FALCON SERVICE BULLETIN

FALCON 900

No 372-R1

**LIGHTING
EXTERIOR LIGHTING
ELECTRICAL BONDING OF WHELEN FIN TIP ANTI-
COLLISION LIGHT**

Figure 8: OPENING IN RIB 3 ON A/C EQUIPPED WITH FAIRINGS F50B319, (A1), (A2) AND FGFB319, (A1)

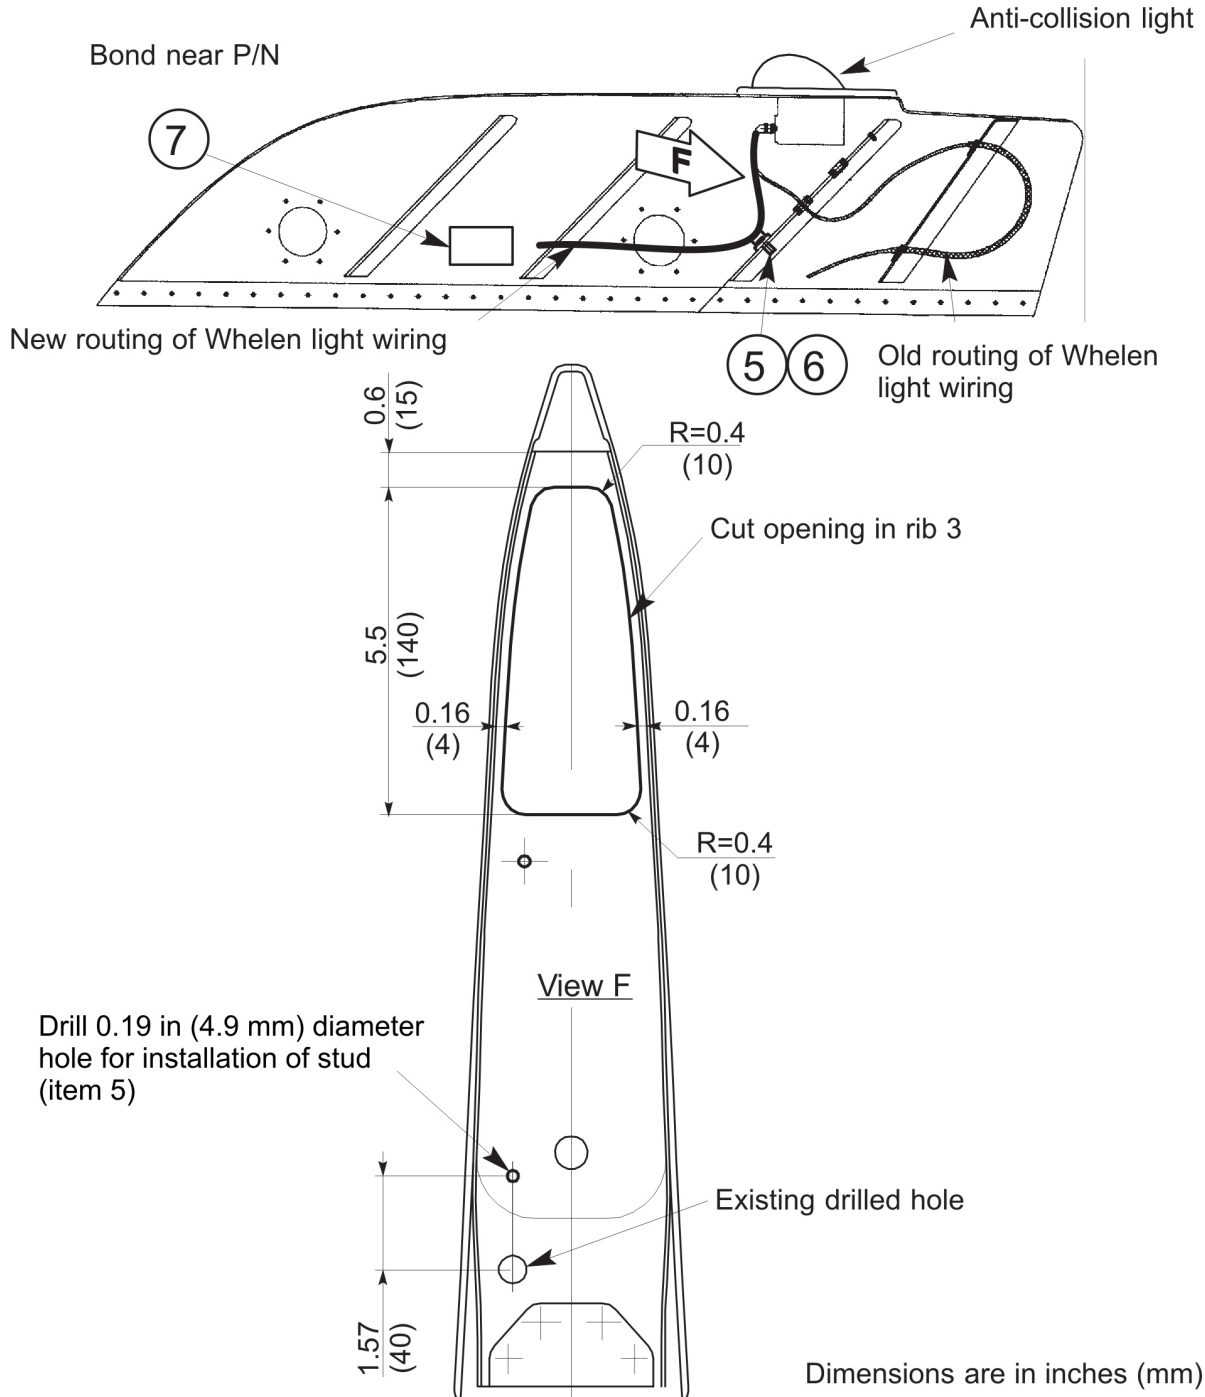
- (3) Machine the cutout in rib 3 in accordance with **fig. 8**.
